UNITED STATES PATENT AND TRADEMARK OFFICE

10/003,058

Office Action Summary

DETAILED ACTION

FIG. 1

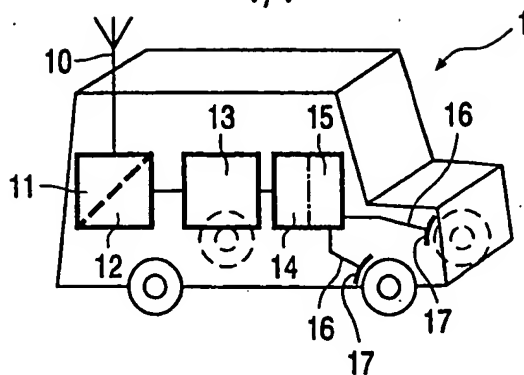
2. The drawings are objected to because there are no labels for each blocks in figures 1 and 2 and blocks 11, 12, 13, 14, 15, and in figure 1, 18 and 19 in figure 2, and 24 in figure 3. These blocks need to have descriptive labels under 37 CFR 1.84(n) and 1.84(o).
